SERVICE INSTRUCTION**Introduction of a new turbocharger assy. with new ECU software and exhaust requirements for ROTAX® Engine Type 915 i A (Series)**

ATA System: 78-20-00 Turbocharger

Introduction of a new turbocharger assy. with new ECU software and exhaust requirements for ROTAX® Engine Type 915 i A (Series).

1 Connection turbocharger bracket with engine suspension frame

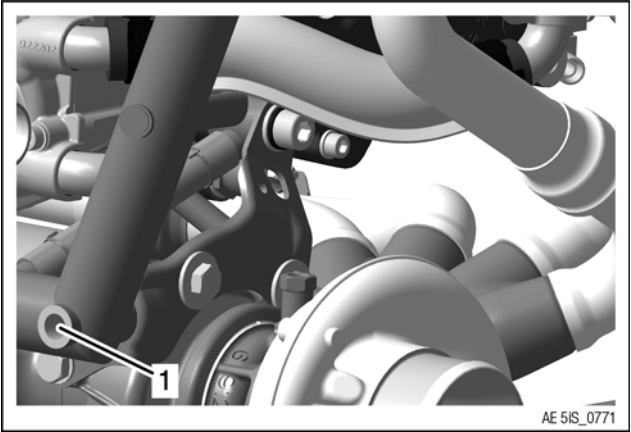
Connection turbocharger bracket with engine suspension frame requires a Metric or UNF fixed connection.

Fig. 16

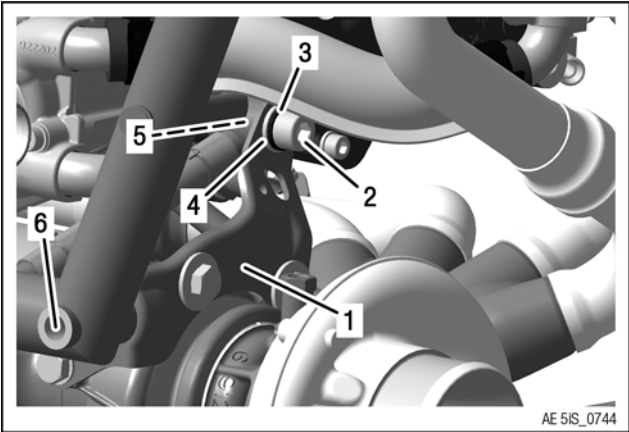
Step	Procedure
1	Place distance spacer 10.5/17/15 into the engine suspension frame.
2	Screw turbocharger assembly to the engine housing, complete with muffler and turbocharger bracket with washer, lock washer and Allen screw M10x50. Tightening torque 60 Nm (44 ft. lb).
